TII Design Report

Development of a Multi-Use Park at The
Common, Lifford, Co. Donegal

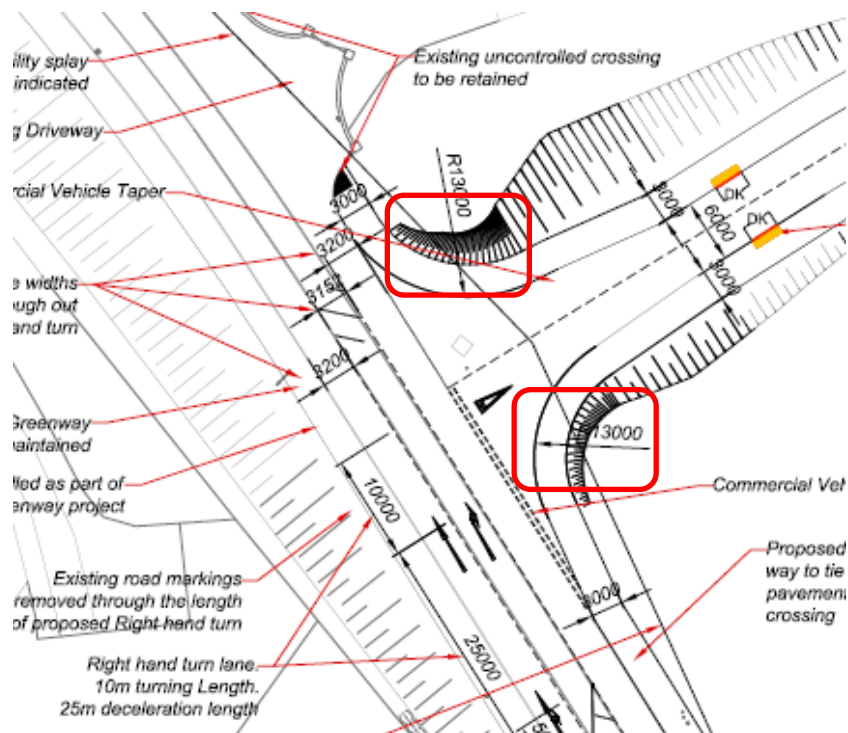
Detail: A 9.0m x 70m visibility has been indicated at the junction. There are a number of warning signs, unauthorised advertising signs and street lighting columns that are likely to be located within the visibility splay. This may interrupt clear visibility to approaching vehicles or non-motorised users. A lack of suitable junction visibility may increase the risk of failure to give way type collisions.

Existing street furniture should be relocated outside of proposed visibility splay.

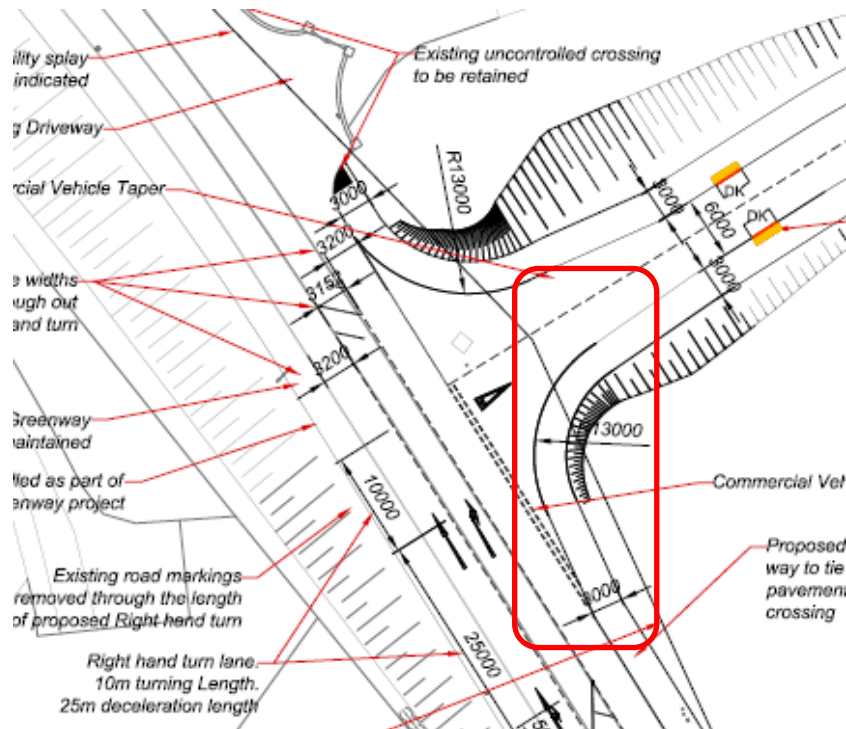
Detail: A 9.0m x 70m visibility has been indicated at the junction. However, the proposed visibility splays appear to pass through an area of cutting which could restrict full junction visibility. A lack of suitable junction visibility may increase the risk of failure to give way type collisions. On the left turn entry to the junction (travelling south along N14), the cutting may restrict stopping sight distance on entry resulting in increased risk of rear end shunt type collisions.

Regrade areas adjacent to proposed access road to provide suitable visibility splays to N14.

Suitable stopping sight distance should be provided on the left turn entry to the access road from N14.

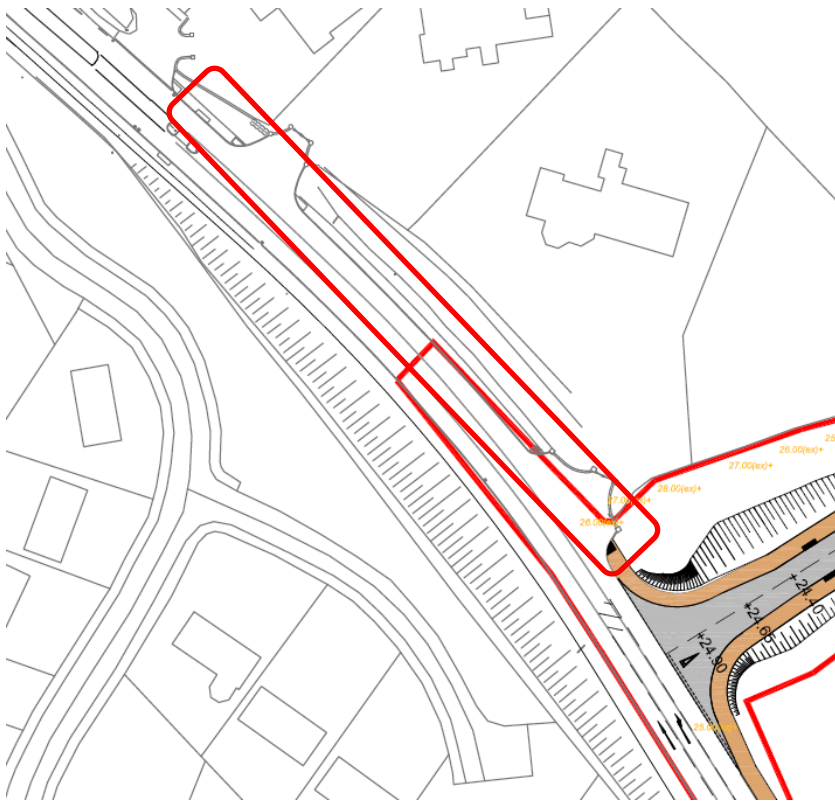
Detail: The proposed development that will be accessed by the new road will likely increase non-motorised activity in the area, with an increase in footway usage. A private dwelling access is located directly adjacent to the proposed junction on the northern side. This is a wide junction with tactile paving located at each side. Carriageway edge markings are not provided across the private access. A lack of carriageway edge delineation increases the risk of a blind or partially sighted user entering the live carriageway with potentially fatal consequences.

Provide suitable carriageway edge delineation.

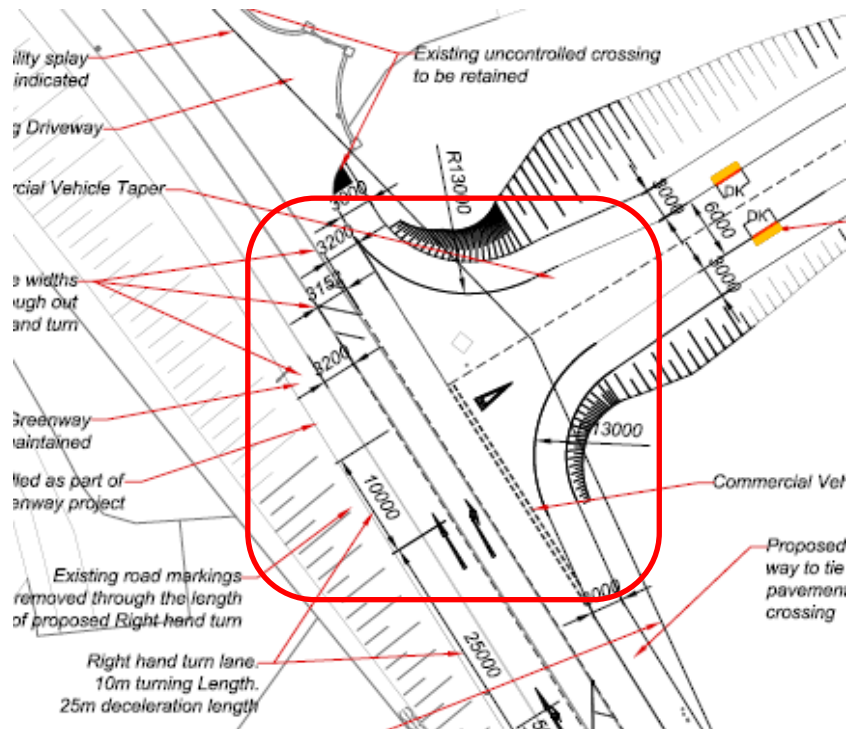
Detail: The proposed access road indicates 3.0m wide combined cycleway / footway on both sides of the carriageway. The cycleway appears to start/end at the northern side of the proposed junction with the N14. However, cyclists on the northern side of the proposed access road that are travelling north are likely to continue north on along the eastern side of the N14 which is currently a 2.0m wide footway. Collisions may occur between pedestrian and cyclists due to the restricted width of existing footway. A cyclist or pedestrian may fall into the live carriageway as a result of conflict, resulting in potentially fatal consequences.

Provide suitable signage and road markings within the proposed site access to direct cyclists to the appropriate crossing point (to the south). However, this will not be a natural desire line for cyclists wishing to travel north. Consider widening the existing footway to the north to provide a combined footway / cycleway up to an existing crossing point approximately 100m north of the proposed access location. Suitable signage and road markings should be provided to indicate provision of a combined footway / cycleway.

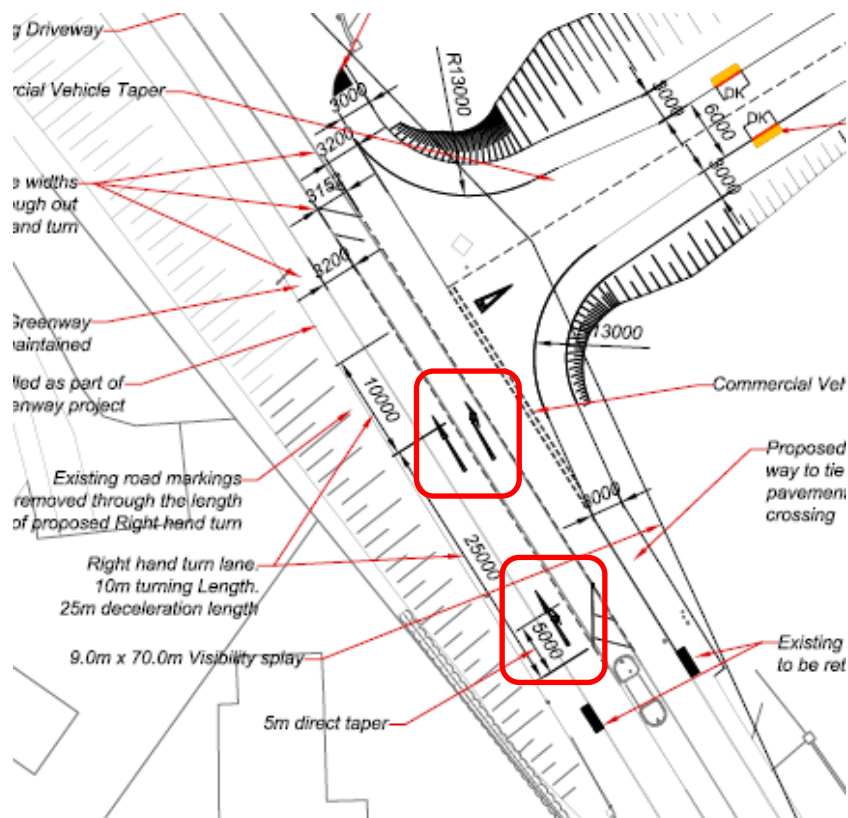
Detail: An existing pedestrian refuge island is located on the southern side of the proposed access. Travelling northbound on approach to the island, a keep left bollard is located within the island. The size of the bollard may restrict driver visibility to a waiting non-motorised user and vice versa. A proposed combined footway / cycleway will cross the N14 at this location which will increase the frequency of crossing movements. A lack of visibility increases the risk of conflict in this area.

Provide a suitable bollard size to reduce the risk of obstructed visibility to/from the refuge island.

PROBLEM LOCATION DRAWING

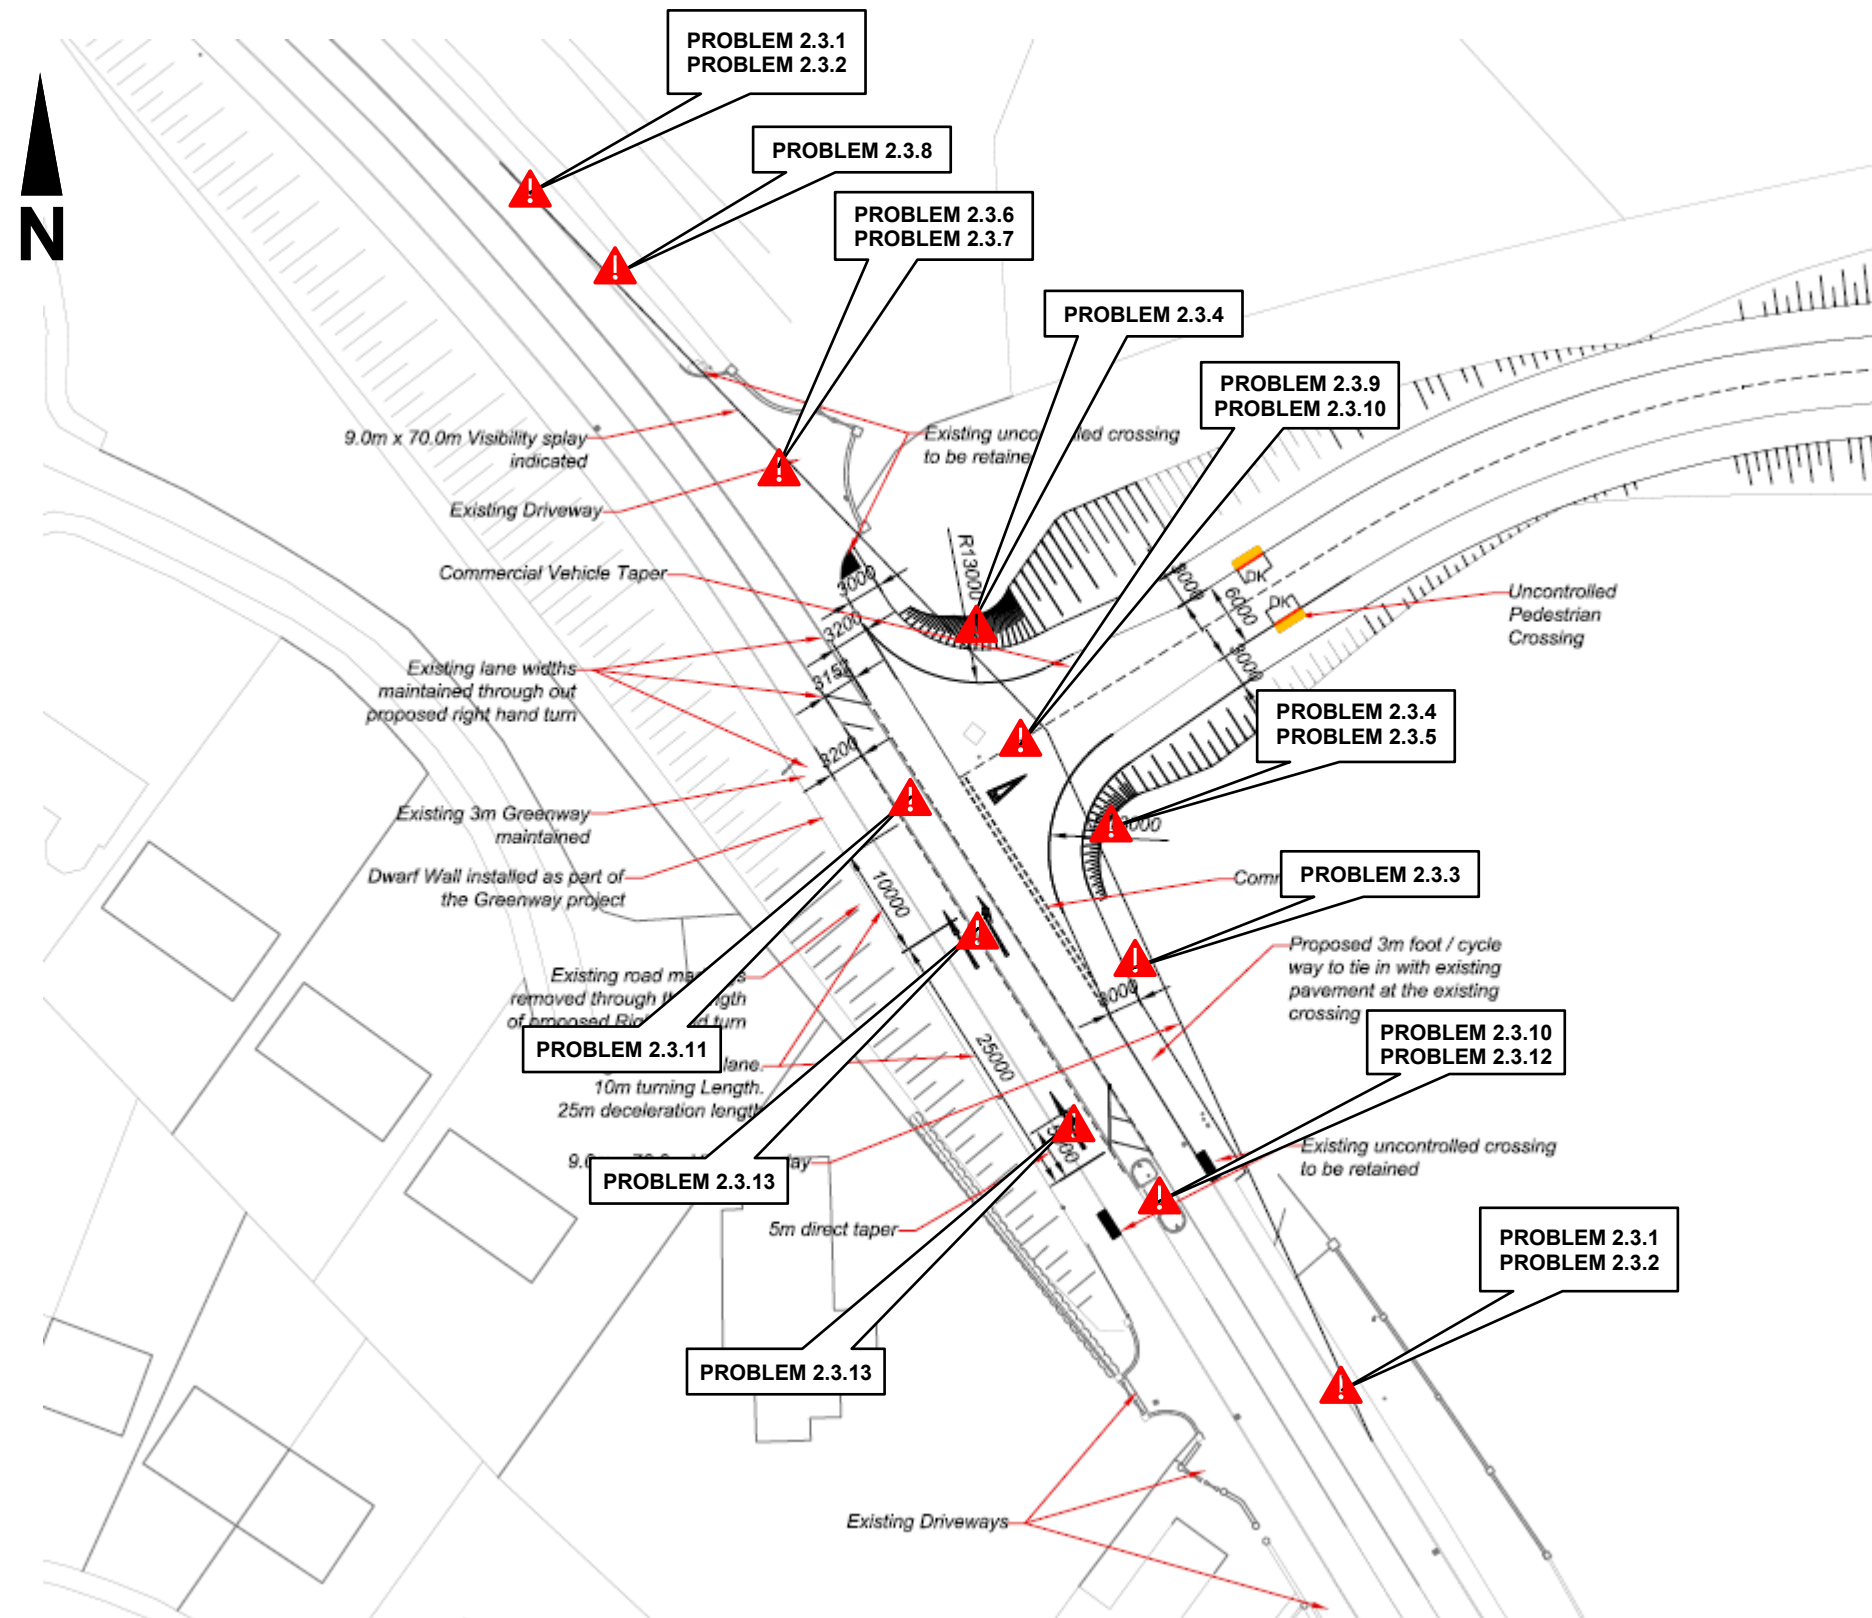
1.17 The locations of problems are marked on the drawing located in Appendix B.
